Office Action Summary

10/760,246

SILVERBROOK ET AL.

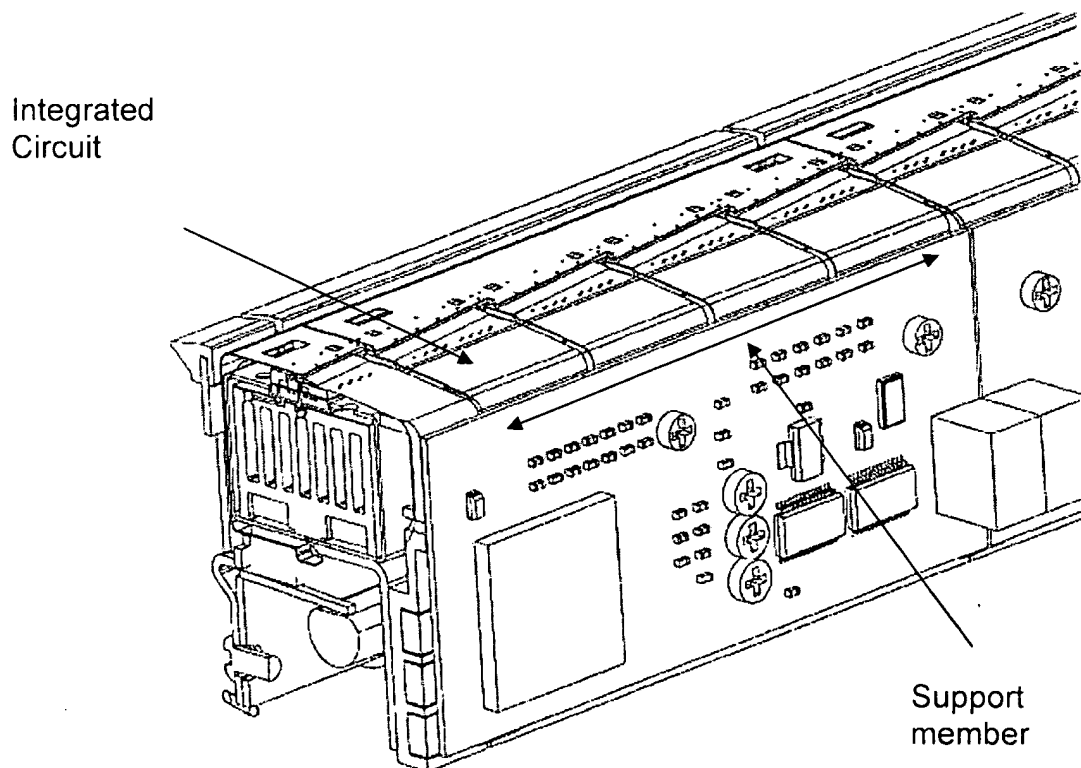
Applicant's arguments filed 10/9/07 have been fully considered but they are not persuasive. Applicant argues that Silverbrook fails to disclose a module with two or more printhead integrated circuits; however, the printhead module with two or more integrated circuits is illustrated in the figure above. The applicant must further define the printhead module and integrated circuits in order to overcome the prior art.
